# UNITED STATES PATENT AND TRADEMARK OFFICE

APPLICATION NO.	FILING DATE	FIRST NAMED INVENTOR	ATTORNEY DOCKET NO.	CONFIRMATION NO.
10/561,532	12/19/2005	Ronald Dekker	NL02 1153 US	9985
24738 7590 11/10/2009 PHILIPS INTELLECTUAL PROPERTY & STANDARDS PO BOX 3001 BRIARCLIFF MANOR, NY 10510-8001				
EXAMINER SHINGLETON, MICHAEL B				
ART UNIT 2815		PAPER NUMBER		
MAIL DATE 11/10/2009		DELIVERY MODE PAPER

### Office Action Summary

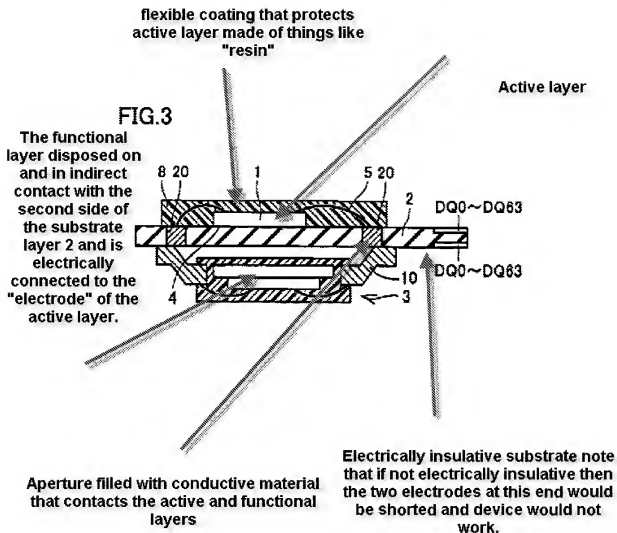
Claim 1 is so so extremely broad. First of all applicant still has not provided a proper drawing to an invention where the functional layer is on the "second side of the substrate". What applicant now points to as element 15 is composed of the same exact material as that of 14 with is pure conductor as presented by the original disclosure. This just cannot be the functional layer, period. Again what was shown in the original disclosure was that of pure conductor and thus there continues to be clear new matter that must be cancelled in response to this office action. However, as stated above claim 1 is so so extremely broad. In essence claim 1 has a circuit on one side and a circuit on the other side of a substrate with a through hole connecting the two circuits. The only other thing added besides just stated is that there is a "flexible coating" formed on the "first side" of the substrate acting as a protective cover. Applicant should be well aware of the numerous flexible circuit boards that exist with through holes where the active or functional elements(layers) are mounted on both sides of the flexible circuit board and connected to each other via the through holes. More "rigid" versions like motherboards common in computers also are commonly known to exist with active and functional layers but all versions are flexible to some degree and applicant just has not claimed nor is there any support in the original disclosure to the degree, i.e. just how flexible is flexible as meant by applicant. The examiner wants to help applicant as much as possible to get to allowable subject matter and because there is no support for the degree of flexibility the examiner cannot suggest a limitation as to the degree as this would introduce new matter into the specification that has already been plagued with numerous errors. Matsumoto has been provided to show that the invention as set forth in claim 1, not withstanding the new matter that exists in the present application, is anticipated by the prior art. The following reproduced drawing should make it clear that claim 1 is clearly anticipated but a few points are discussed as well to further emphasis this point. Applicant says that the active layer includes "at least one switching element". Well many things can be consider a "switching element" and as Matsumoto intends to use memory chips as the active layer the memory devices contained therein can be called "switching elements" as there state i.e. a 1 of a 0 is switchable. Resin is clearly flexible and is listed as one of the "flexible materials" by applicant. The term "monolithic" is likewise very broad. Clearly even applicant's invention is not "formed from a single crystal". Applicant's invention it is like that of Matsumoto "consisting of or constituting a single unit" i.e. monolithic. Should applicant like to
